**ADDENDUM NUMBER #1**

<u>PROJECT</u>	<u>BIDS DUE</u>
City of Clare - 2023 Water Treatment Facility Upgrades GFA Project No: 22253	Date: April 27, 2023 Time: 3:00 PM Location: City of Clare 202 West Fifth Street, Clare, MI 48617

**CITY OF CLARE**  
**2023 WATER TREATMENT FACILITY UPGRADES**  
**WTF ELECTRICAL FLOOR PLAN**  
**CITY OF CLARE, CLARE COUNTY, MICHIGAN**

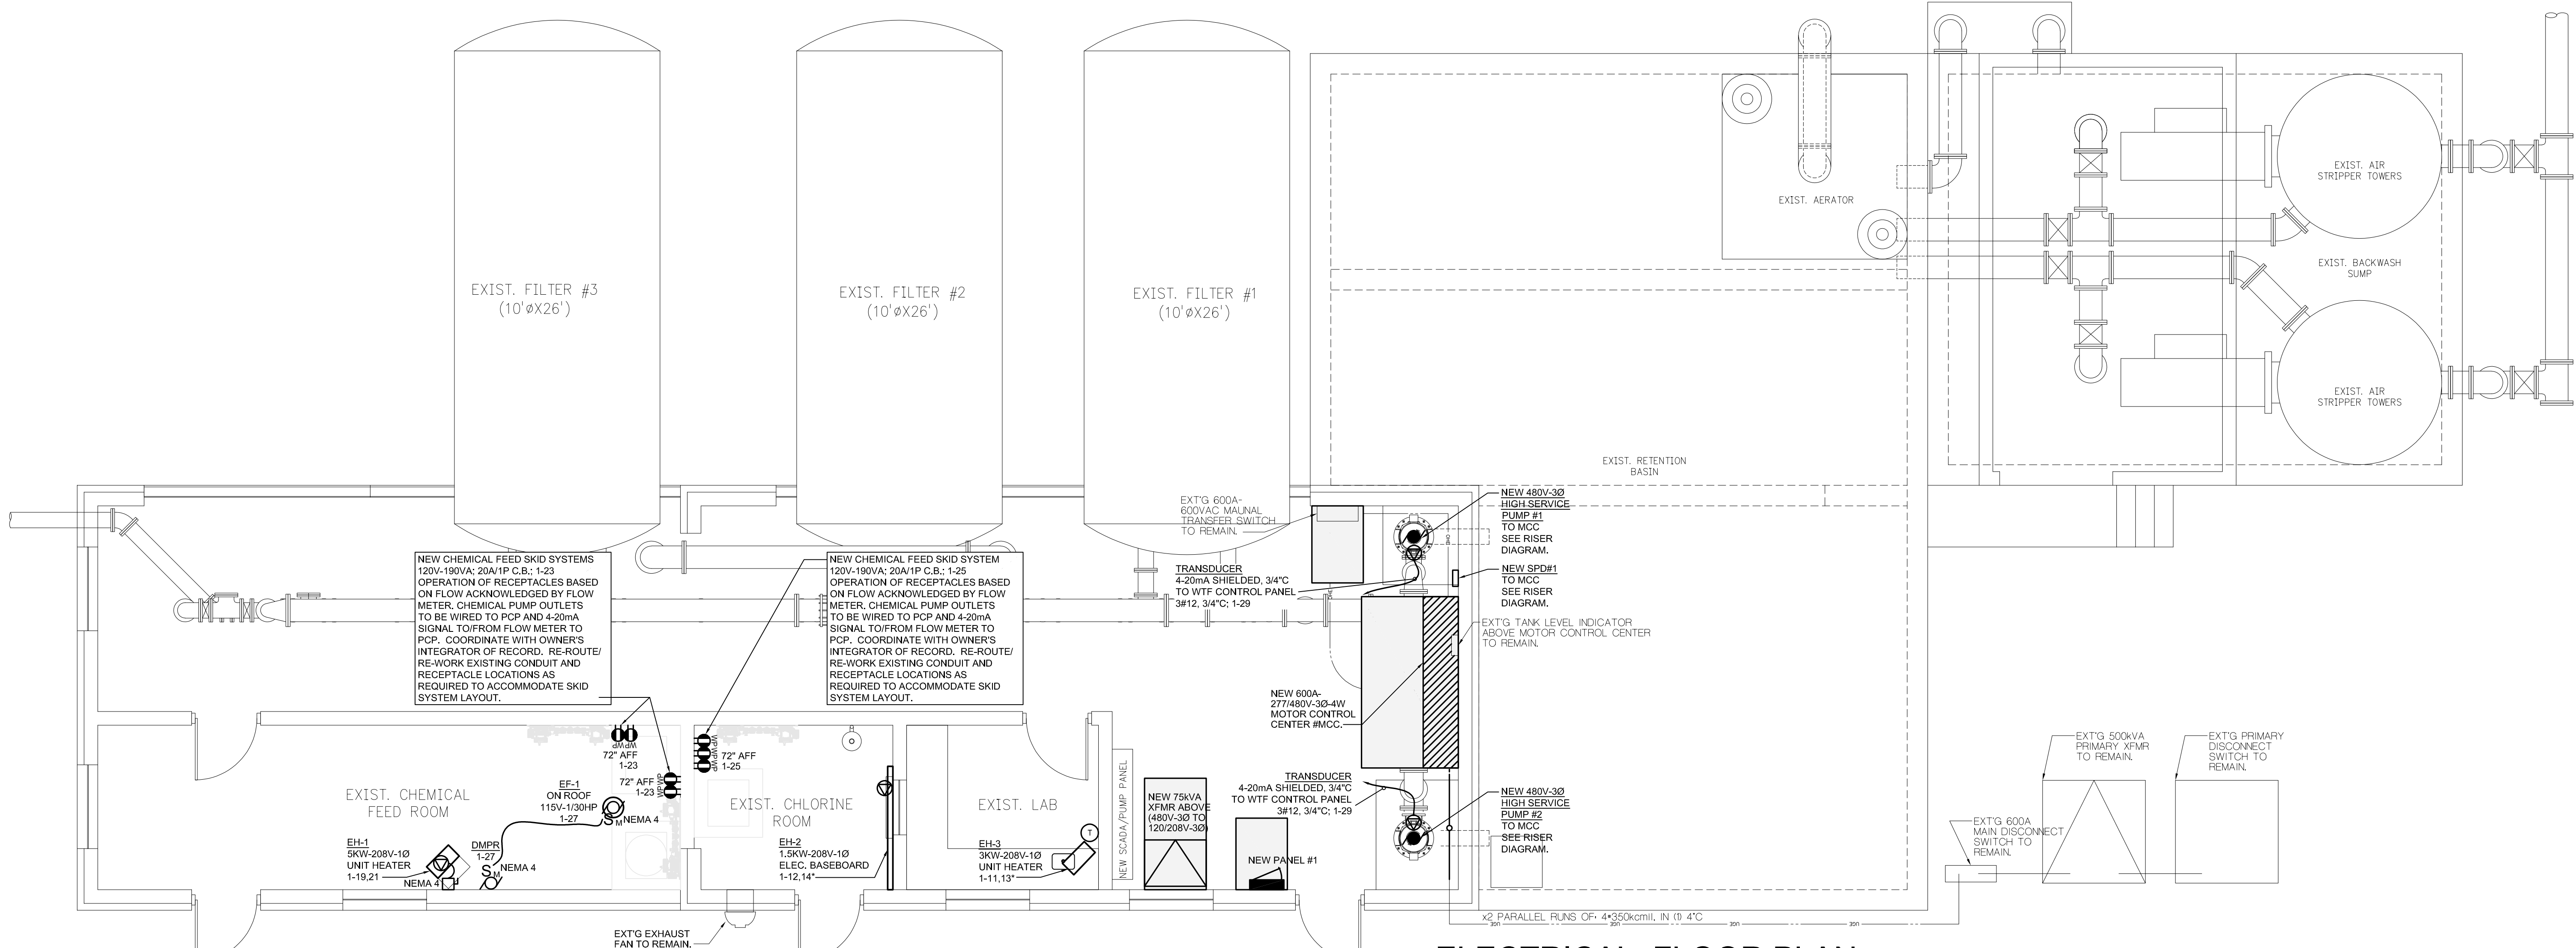
7. Sheet 2.6, Detail 3 Clarification: The sample tap shall be stricken from detail and only to include transducer (transmitter) and/or pressure gauge.
8. Sheets 2.11 – WTF Electrical Floor Plan and 2.12 – WTF Electrical Riser Diagrams, Schedules, and Details

The High Service Pumps are changing from 75 HP, 85 FLA to 100 HP, 112 FLA. See changes required on revised sheets 2.11 and 2.12 to reflect this change, including increasing the Variable Frequency Drives sizing. These drawings shall supersede the existing drawings.

12. Sheets 2.11 and 2.12 Feeder Wire Clarification: Drawings show 2-sets of parallel runs of 4-350MCM in the same 4" conduit that's being reused. The intent is due to unknown existing conditions and whether splices exist that it is proposed contractor installed new conductors run for both new routes: Main Disconnect to MTS and from MTS to new MCC.
